Modernization of Technical Requirements for Licensing of Advanced Non-Light Water Reactors

Selection of Licensing Basis Events
Draft Report Revision 0

Note that the NRC staff comments within this draft document are intended to be considered along with the high-level comments provided. There may be other changes needed within the draft to ensure consistency and to reconcile the draft with the resolution of comments or response to questions.

Figure ES-1 Process for Selecting and Evaluating Licensing Basis Events

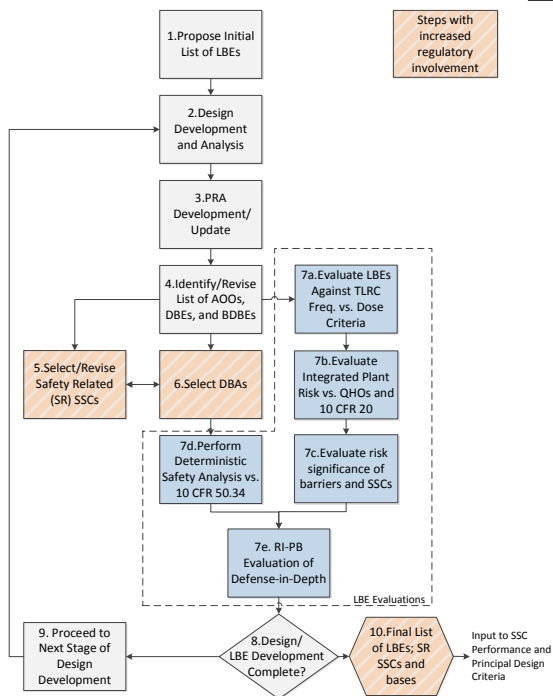
Consider additional box to consider outcomes in terms of emergency planning and siting

Figure ES-2 Frequency-Consequence Evaluation Criteria Proposed for LMP

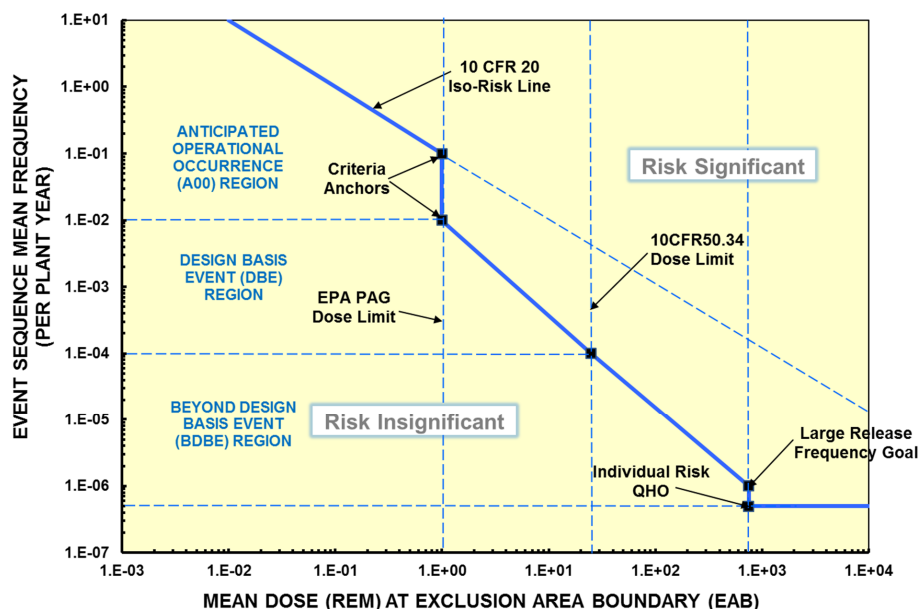
[Suggest “Decreasing Risk” and “Increasing Risk”, with Arrows versus terms implying acceptability or significance. In line with treatment as a tool and not using lines as criteria.](#)

Figure 3-5 Frequency-Consequence Evaluation Criteria Proposed for LMP

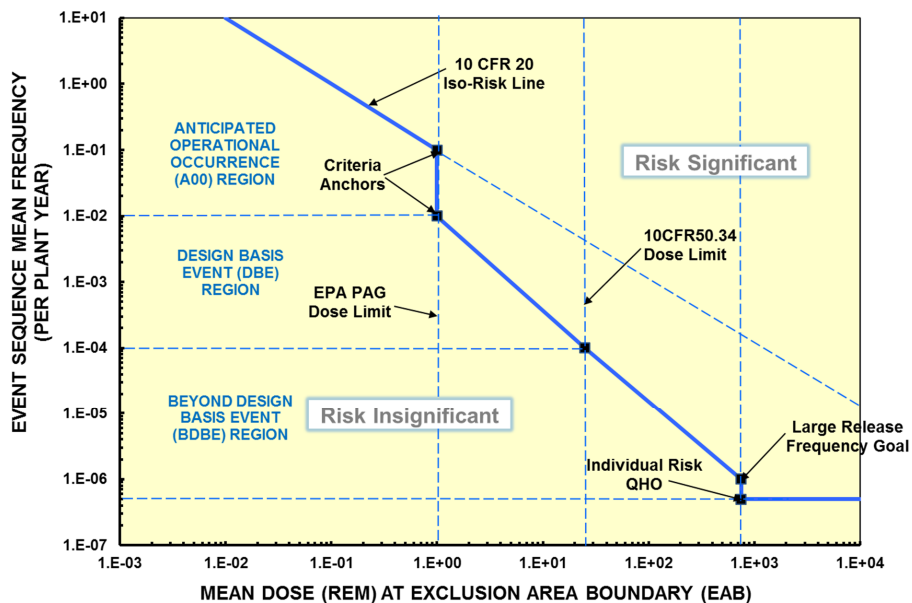
The ~~TLRC~~ frequency-consequence evaluation ~~criteria~~ correlation proposed for the LMP project are shown in Figure 3-5. ~~These~~ This correlation is ~~criteria~~ are based on the following considerations:

- The ~~dose criteria~~ F-C line for the BDBEs range from 25 rem at 10^{-4} /plant-year to 750 rem at 1×10^{-6} /plant year to meet the anchor point for the LRF goal. The BDBE doses from 1×10^{-6} /plant year down to 5×10^{-7} /plant-year are fixed at 750 rem, providing continuity with the lower end of the DBE region and using the same conservative interpretation of the early health effects QHO as used to anchor this end of the NGNP criteria. [Clarify which are event goals and which are integrated goals]
